SERVICE DES BASSES TEMPERATURES

Cooler Tutulace Meeting (CIM 2001-01) Minutes of Meeting ref. : Date: 12 January, lood Cooler Subject : Discussion on ink ENOBLE Meeting date : Place FA CB Copies : Those present + Chair : lione DUBAND Bruce Swinyord Present : han low's Auguers Sam theys I RAZ (RHL ohn Belderfield Berend Winter MSSL loker MSSI erome Martiguac allenta Kojei 1 Dave Jauren SBi lauren Guilleme Dubang None

Ref. Meeting: CIM 2001-01 Date: January 12<sup>44</sup>, 2001 Page Jof 5

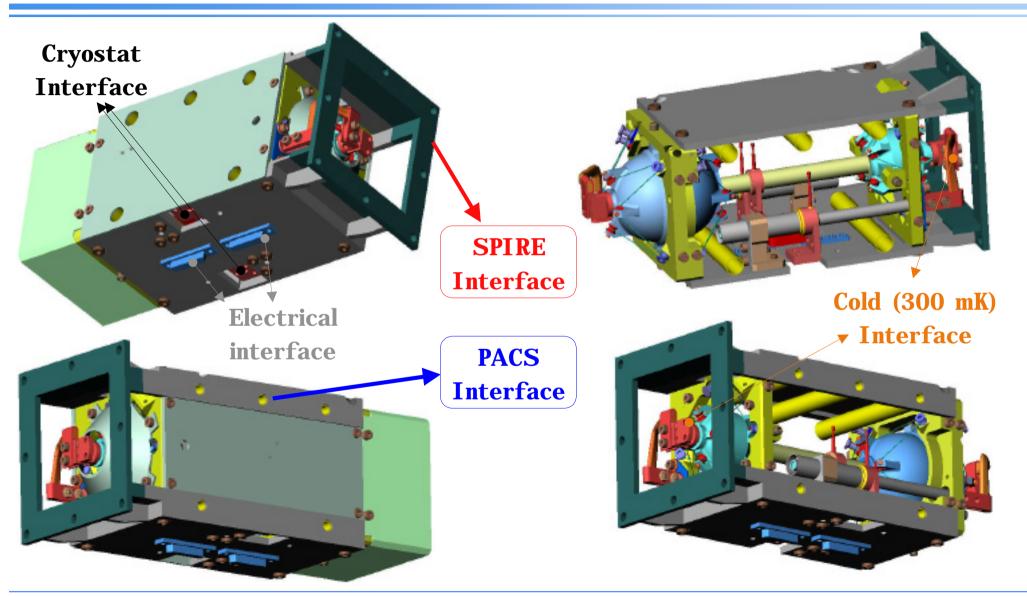
- 300 mK interface
  - need efficient conductance + easy access +
    no constraint on cold tip + SPIRE/PACS compat.
- "Cold" wires thermal coupling
  - Grooves to be added on thermal shunt
- Thermal straps (heat switches)
  - Evaluation in progress.
- Thermal straps to cryostat
  - interface with switch base :

reinforce the base tube versus cooler perf.?
